To:	North Castle Engineering Kellard Sessions, Joseph Cermele, P.E.		
From:	Ahneman Kirby, LLC - Keith Werner		
Project:	Eric Birenberg 16 Quaker Meeting House Rd Armonk, NY 10504		
RE:	Eric Birenberg 16 Quaker Meeting House Rd Section 101.03, Block 4, Lot 44		
Subject:	Site Development Review Comments and Conditions of Approval	AKL Project No:	20-087-D083
Comment Date:	March 5, 2021	Response Date:	March 23, 2021

PREPARED FOR:  
**BIRENBERG RESIDENCE**  
18 Quaker Meeting House Road, Armonk, NY 10504  
(Tax ID: 101.03-4-44)  
**PROPOSED POOL PLAN**  
SP-1

**DRY STACK BOULDER RETAINING WALL SECTION**

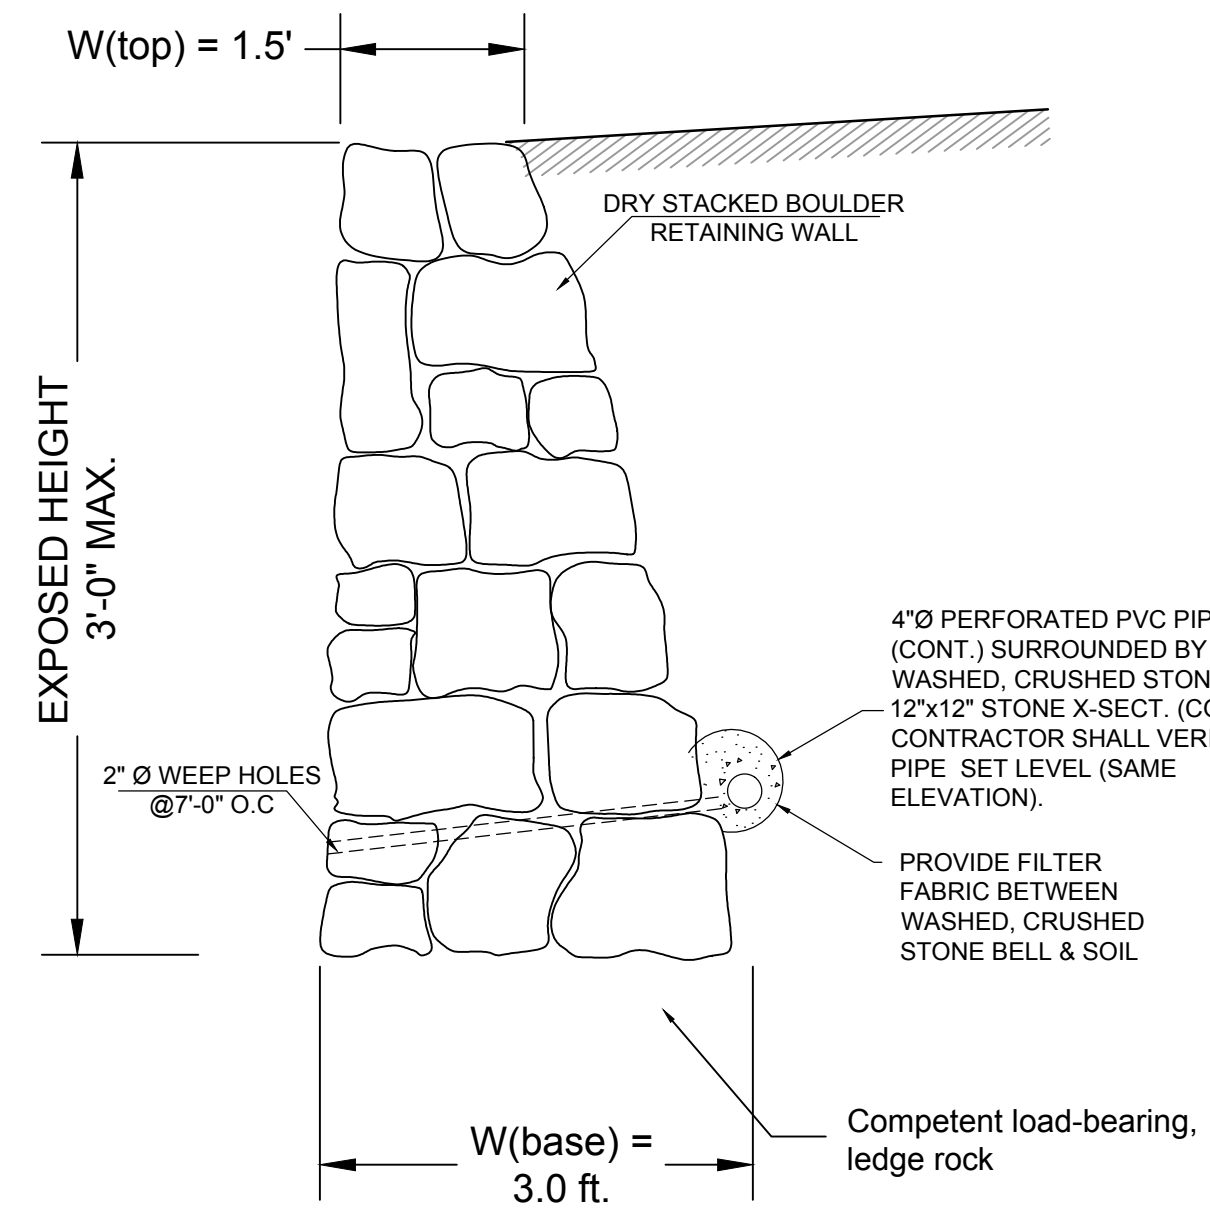
14	The plan shall note the construction sequencing for the proposed pool development.	General Comments	Joseph Cermele, P.E.	A construction staging sequence has been added to the plan.
15	The plan shall illustrate the proposed elevation of the pool coping.	General Comments	Joseph Cermele, P.E.	Spot elevations have been added for the proposed pool coping and surrounding area.
16	The plan shall include a detail for the proposed retaining wall.	General Comments	Joseph Cermele, P.E.	A retaining wall detail has been added.
